APPROVED MINUTES

June 20, 2013 Standards Committee Meeting **(Changes by the Action of the Committee on September 19, 2013 meeting highlighted yellow)**

RE: Minutes from the June 20, 2013 Standards Committee Meeting

802-SCSB-09 SIGN CANTILEVER STRUCTURE BUTTERFLY FOUNDATION AT 45"
CONCRETE BARRIER (REVISED DRAFT, approved on September 19, 2013)

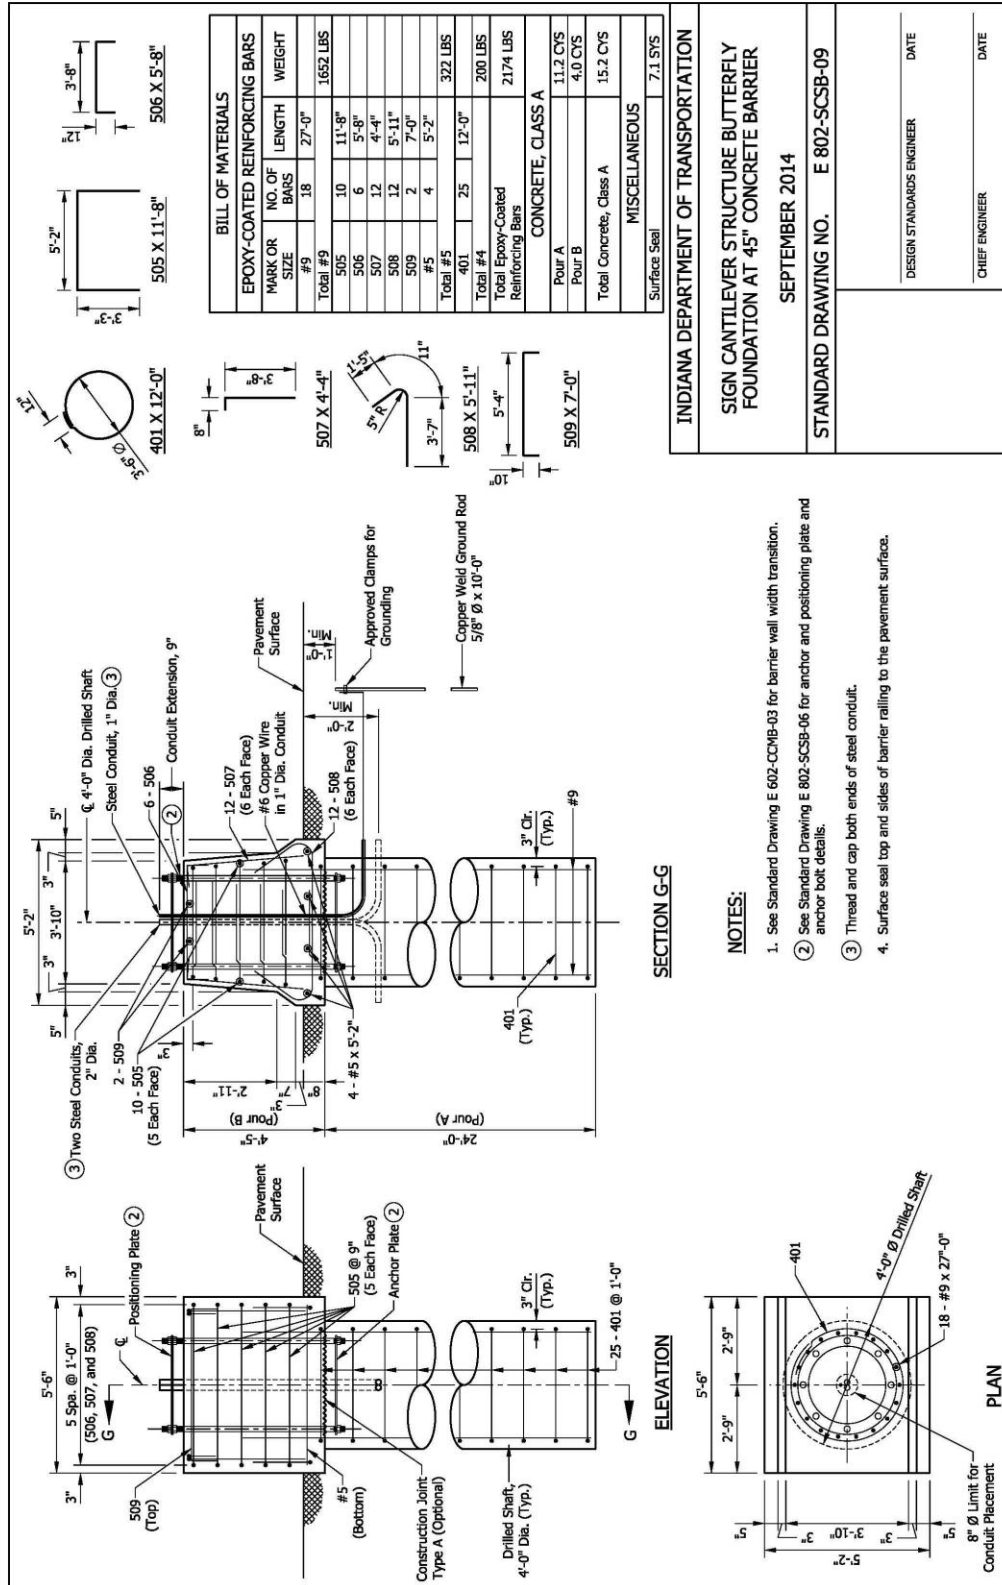
Mr. Hanza asked to make a change to Note 1 on drawing 802-SCSB-09 concerning the 28° friction angle. Mr. Hanza would like to change it to 30°. Ms. Phillips confirmed that the 30° is consistent with the other foundation designs, as is shown on drawing 802-SCSB-08. Following the meeting it was decided to remove Note 1 on sheets 8 and 9 of this set of drawings to be consistent with sign and signal traffic structures (sign cantilever, tri-chord, DMS, etc.) standard drawings recently approved. The remaining notes were renumbered accordingly. The revised drafts of these sheets are shown in these minutes.
